From: [Wolfenbarger, Jeanne](#)
To: ["Vinny Perea"](#)
Subject: Freddy's (Formerly Whataburger)
Date: Monday, June 01, 2015 4:37:00 PM

RE: **Whataburger
Grading Plan
Engineer's Stamp Date 2-18-2015 (File: K10-D001B)**

**RE: FREDDY'S (PREVIOUSLY WHATABURGER), 111 COORS BLVD. NW
GRADING AND DRAINAGE PLAN
ENGINEER'S STAMP DATE 2-18-2015 (K10-D001B)**

**FREDDY'S AT
COORS AND CENTRAL
GRADING AND
DRAINAGE PLAN**

RONALD R. BOHANNAN P.E. #7868	ENGINEER'S SEAL	FREDDY'S AT COORS AND CENTRAL	DRAWN BY BJF
		STORMCHAMBER STORAGE SYSTEM	DATE 05/11/15
		TIERRA WEST, LLC 5571 MIDWAY PARK PLACE NE ALBUQUERQUE, NM 87109 (505) 858-3100 www.tierrawestllc.com	2015036-GRB-DETAILS
			SHEET # C3 JOB # 2015036

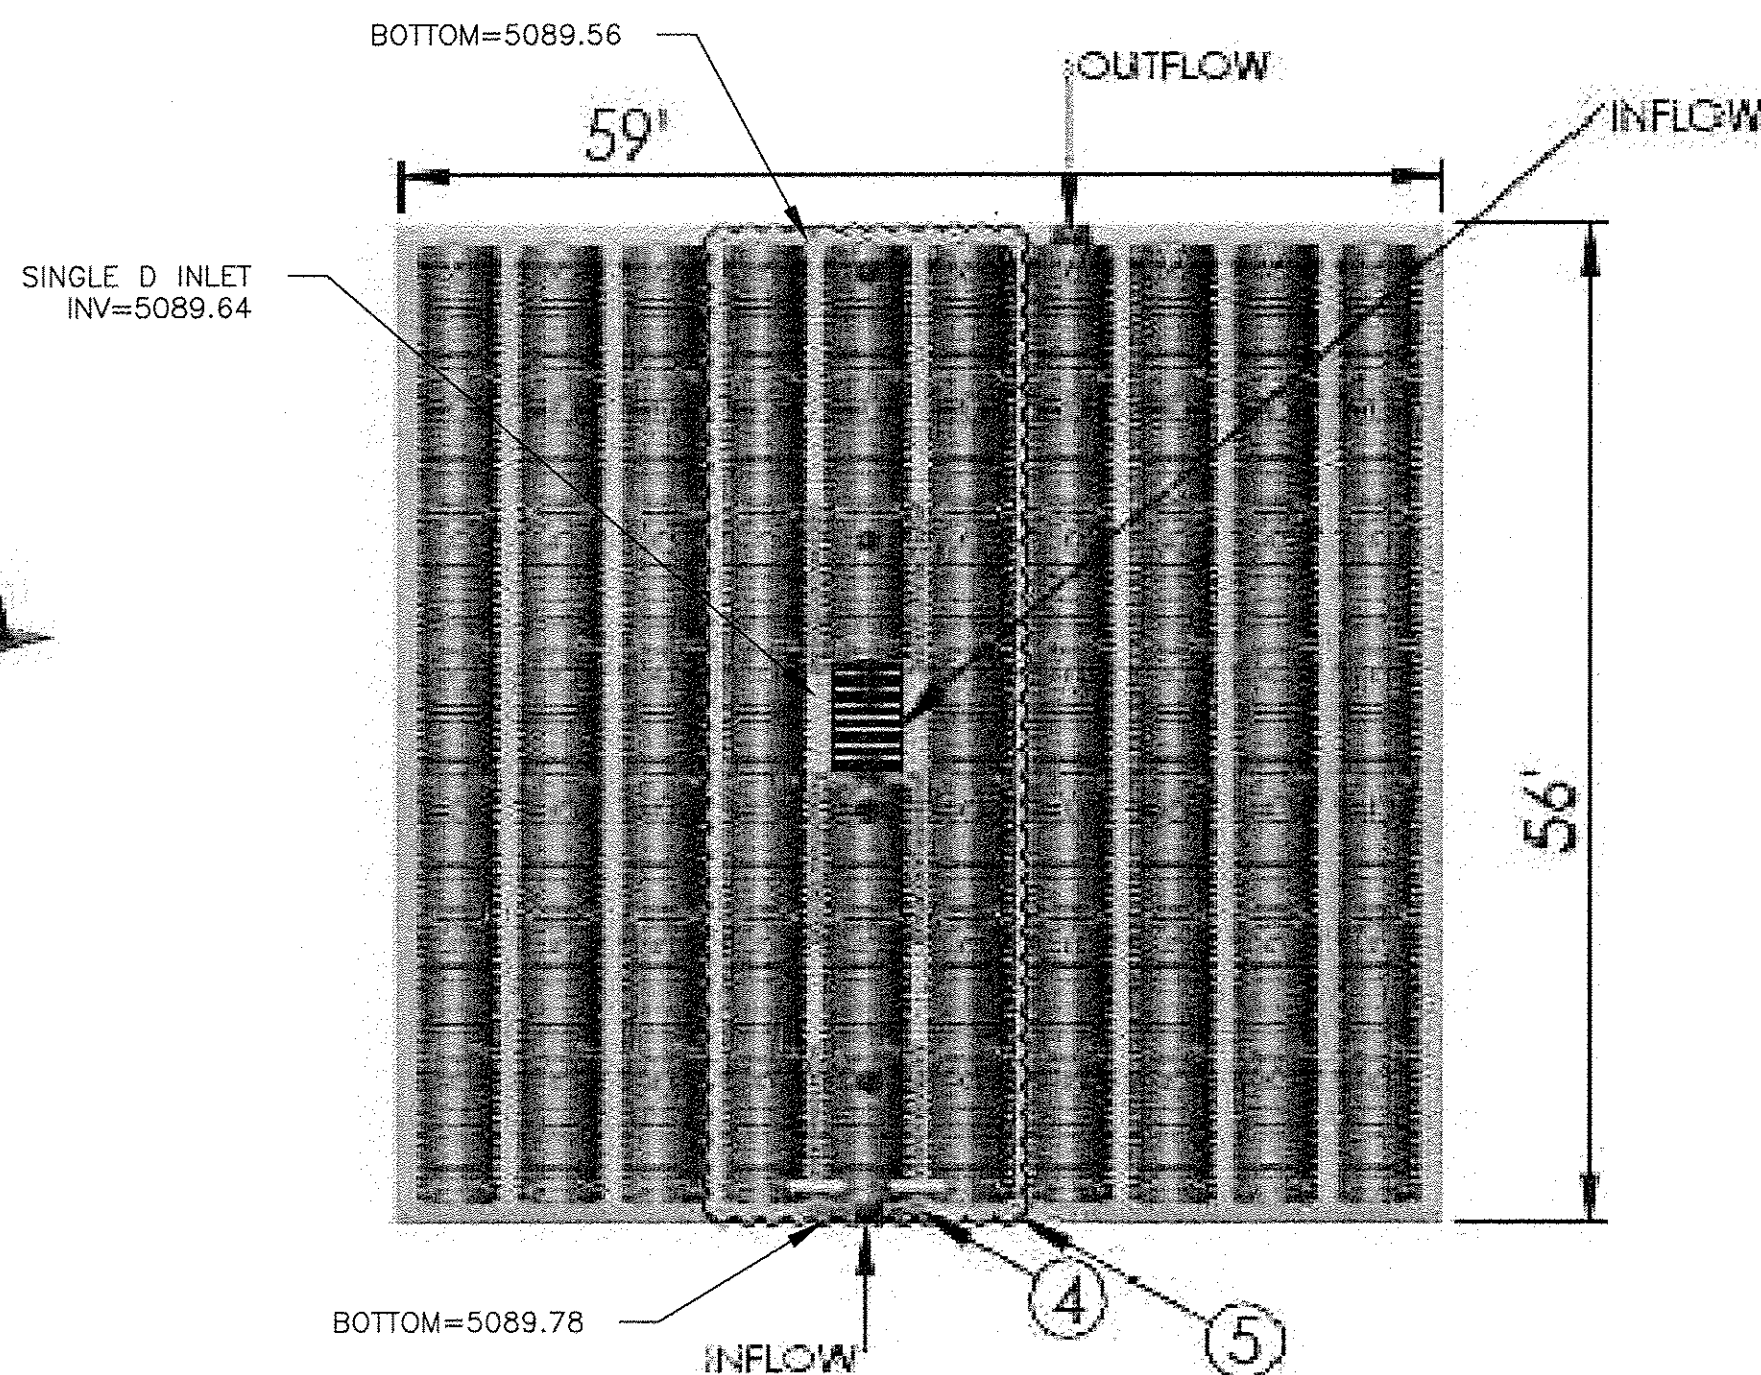
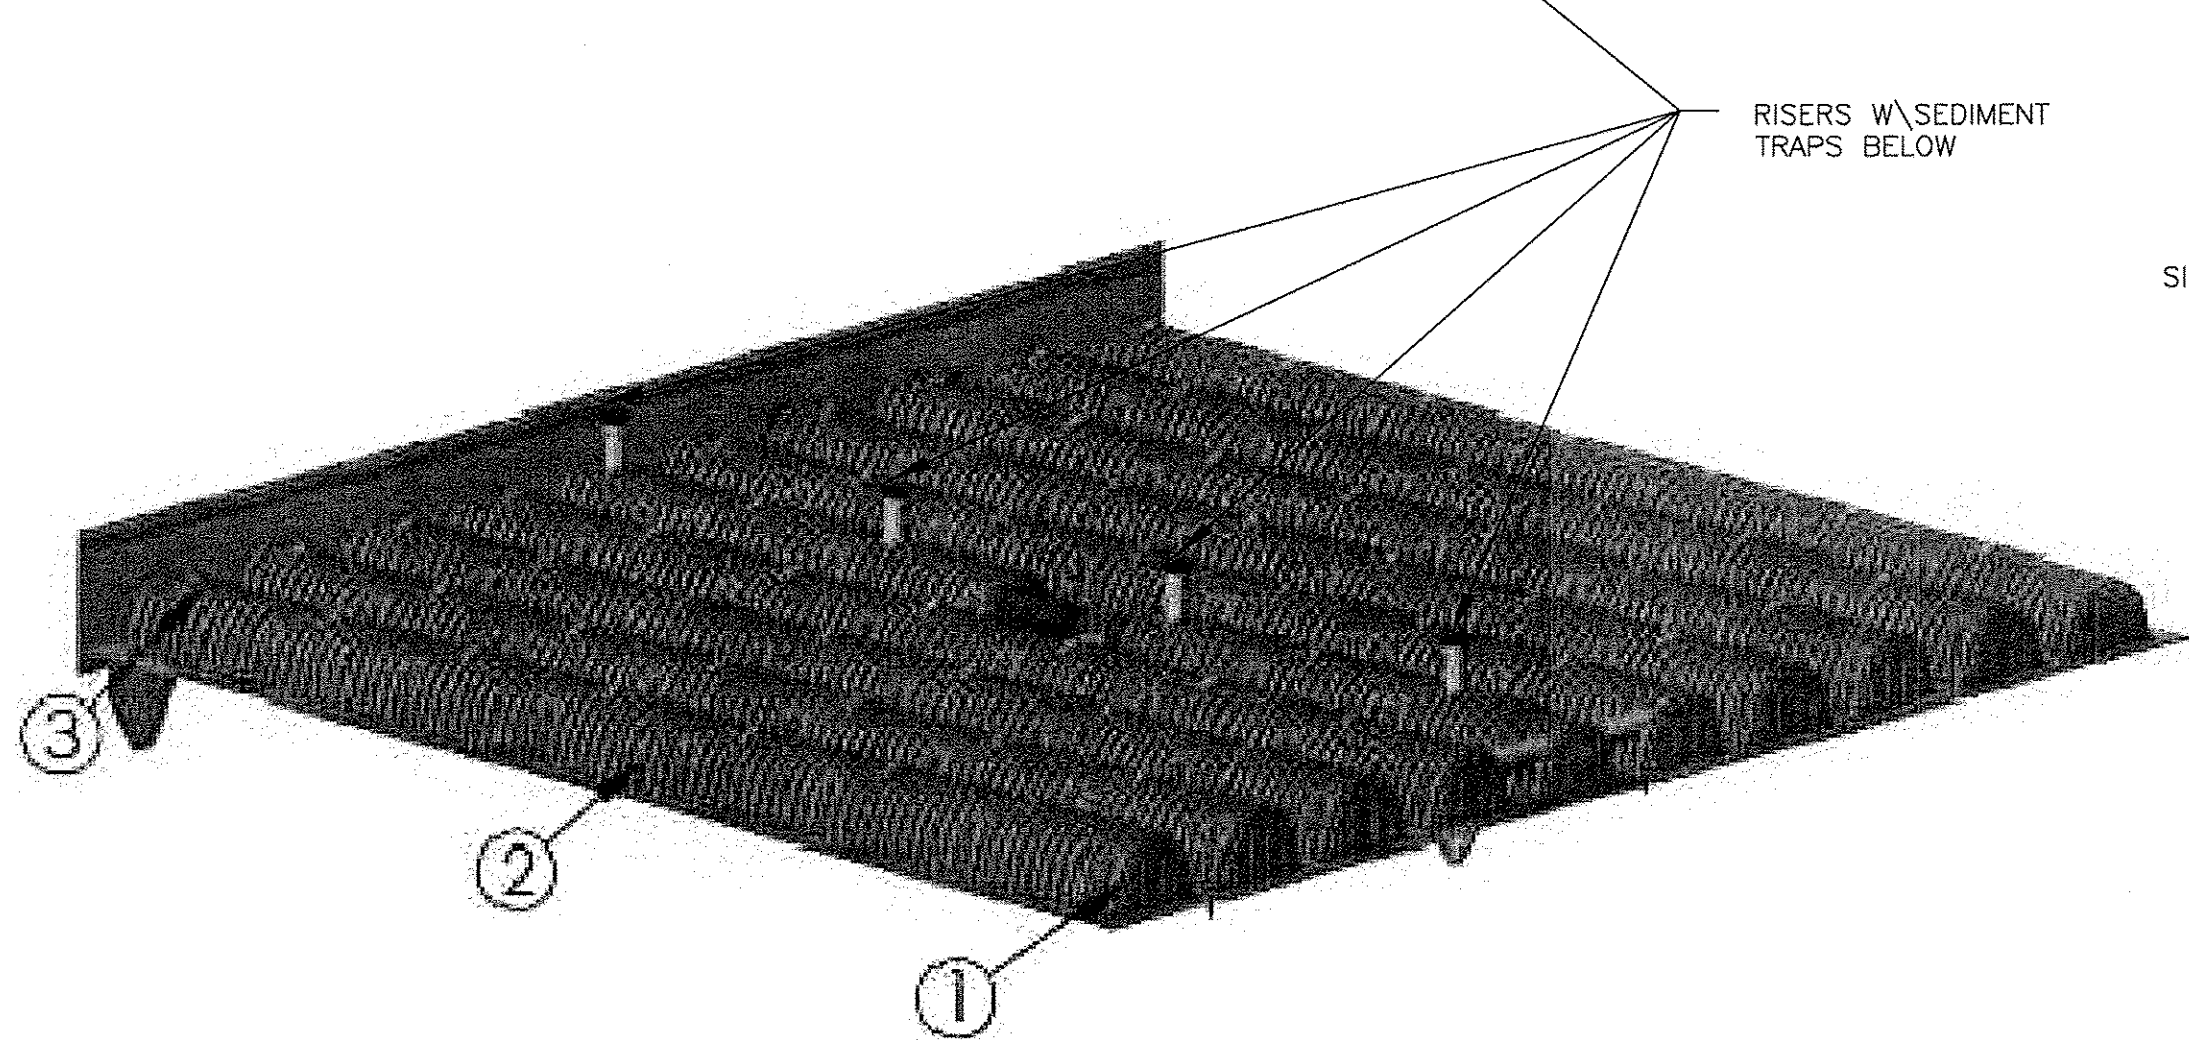
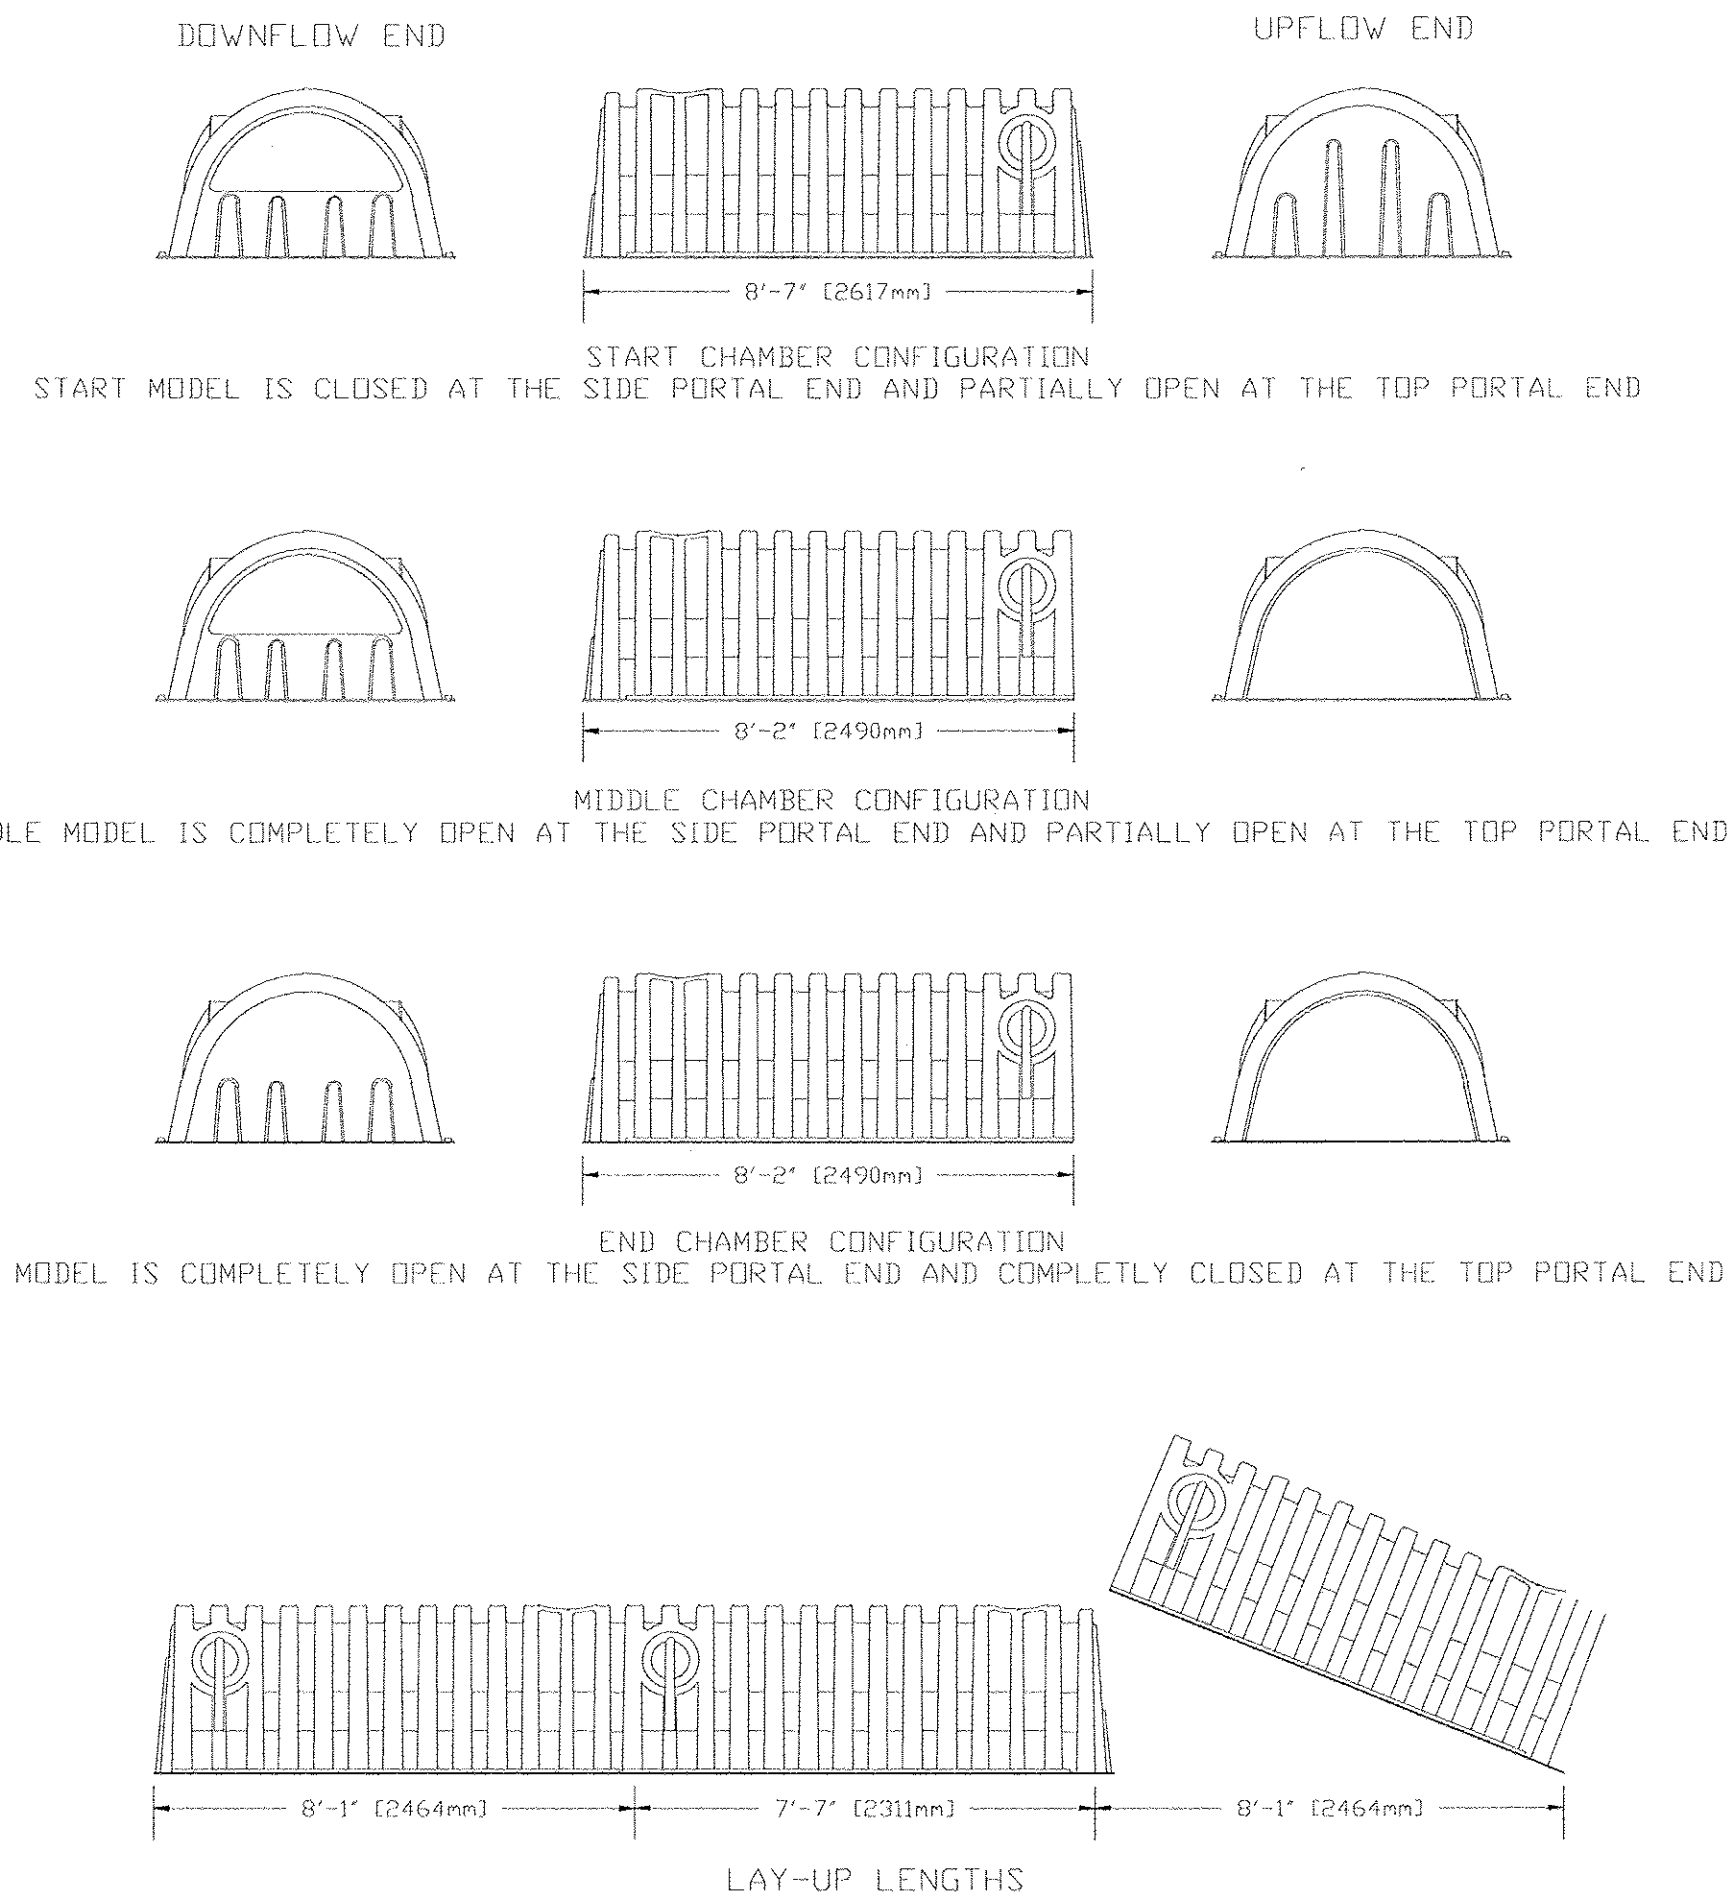
- 9) The number of chambers shown on the "Basin Map and Calculations" sheet is 75. This needs to be called out on the plan view detail on the "Stormchamber Storage System" sheet to make sure the right number of stormchambers will be installed. Also, please provide a legible table showing the layout dimensions for the stormchambers.

9. The number of chambers shown on the "Basin Map and Calculations" sheet is 75. This needs to be called out on the plan view detail on the "Stormchamber Storage System" sheet to make sure right number of stormchambers will be installed. Also, please provide a legible table showing the dimensions for the stormchambers.

Response: The number of chambers was reduced from 75 to 69. This was modified in the Stormchamber volume calculations and is called out on the plan view detail on the "Stormchamber Storage System" sheet. The table showing the material quantities and the cross sections of the chambers was modified to be more legible.
